HOLDOVER

THE ROCK CHURCH SUBDIVISION

APPLICATION NUMBER Holdover DATE January 5, 2006

THE ROCK CHURCH SUBDIVISION

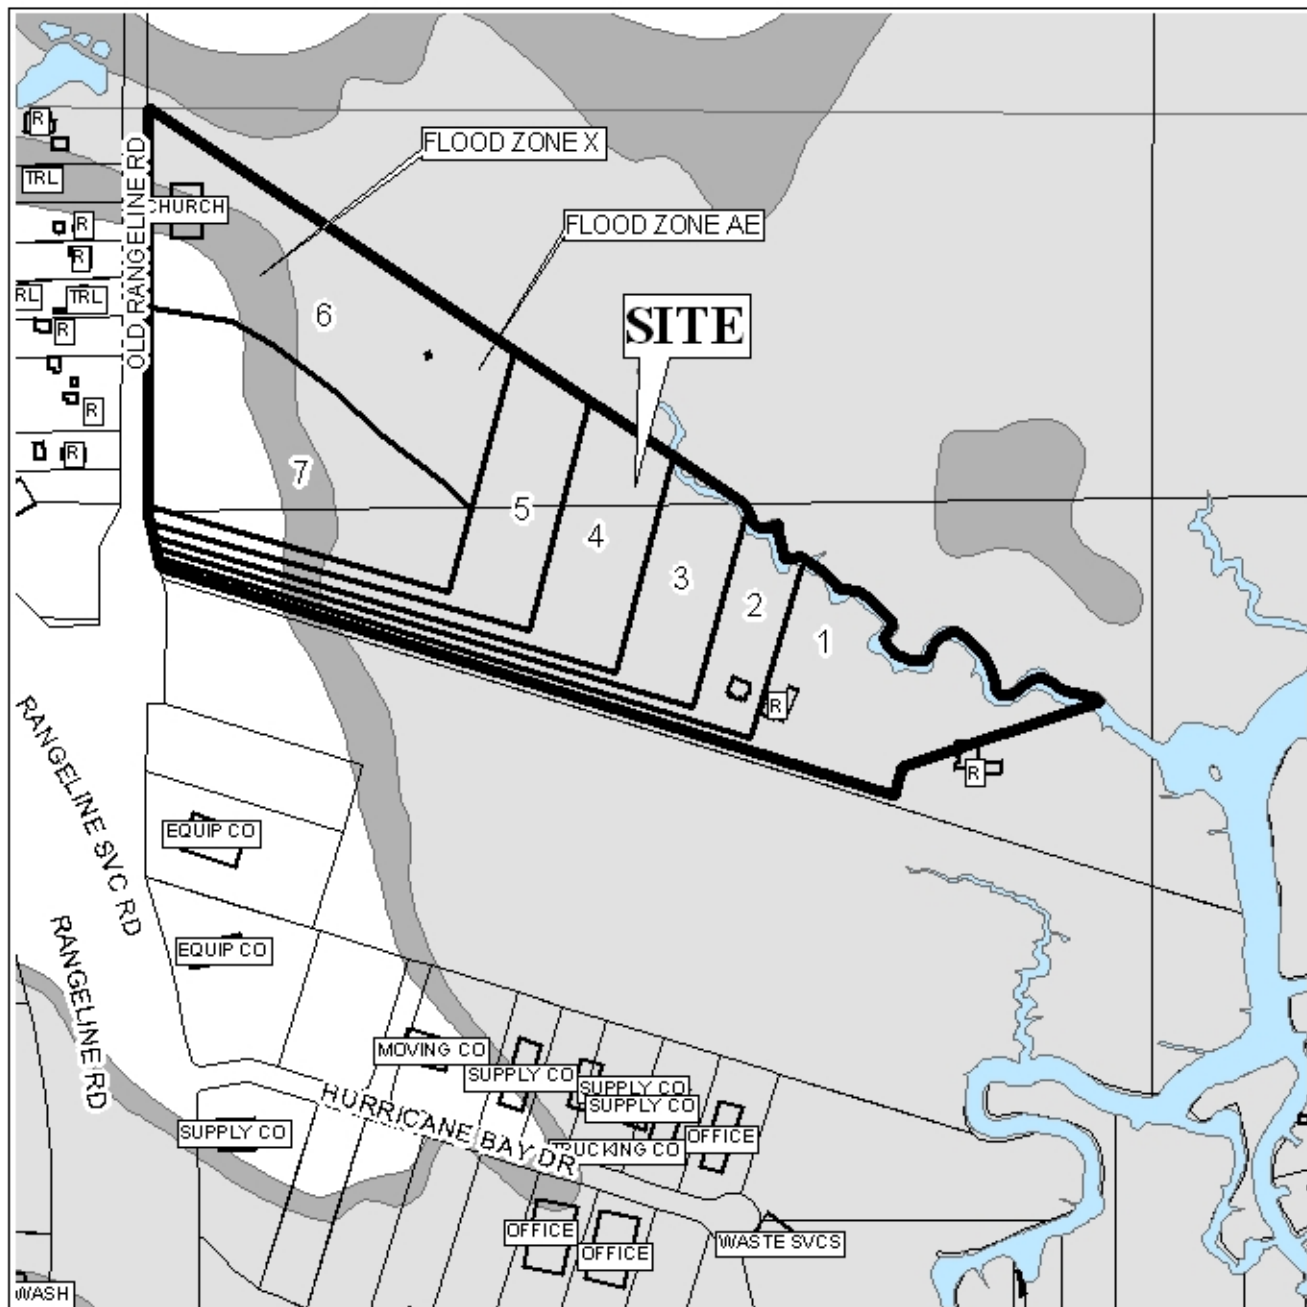
Lots 1- 5 are proposed to be flag-lots with 25-foot wide strips ranging from approximately 741 feet to 1,626 feet in length, connecting them to Old Rangeline Road. If the "pole" portion of the flag-lots is excluded, all proposed lots meet the recommended depth to width ratios of Section V.D.3. Lots in the vicinity of Alligator Bayou exhibit high depth to width ratios due to the desirability of waterfront lots and the extensive wetlands in the area. Flag-lots exist along the Alligator Bayou / Dog River area, however, they create an undesirable land subdivision condition which, in this case, could easily be remedied through the provision of a public street following the existing access road on the site, or via the creation of an innovative subdivision with a private street, in conformance with Section VIII. of the Subdivision Regulations.

Based upon the preceding, the application is recommended for Denial for the following reasons: 1) the extreme flag-shaped nature of the proposed Lots 1-5 are uncharacteristic of other lots in the area, with the exception on the one adjacent flag-lot, and thus do not comply with Section V.D.1. of the Subdivision Regulations; and 2) the proposed Lots 1-5 exceed the maximum depth to width ratio identified in Section V.D.3. of the Subdivision Regulations.

This application was heldover from the November 17th meeting. As no additional information has been provided for the January 5th meeting, this application is recommended for denial for the following reasons: 1) the extreme flag-shaped nature of the proposed Lots 1-5 are uncharacteristic of other lots in the area, with the exception on the one adjacent flag-lot, and thus do not comply with Section V.D.1. of the Subdivision Regulations; and 2) the proposed Lots 1-5 exceed the maximum depth to width ratio identified in Section V.D.3. of the Subdivision Regulations.

Based upon the preceding, the application is recommended for Holdover for the following reasons: 1) redesign of the proposed subdivision to provide access via a public street, or creation

of an innovative subdivision with private street, in conformance with Section VIII. of the Subdivision Regulations.
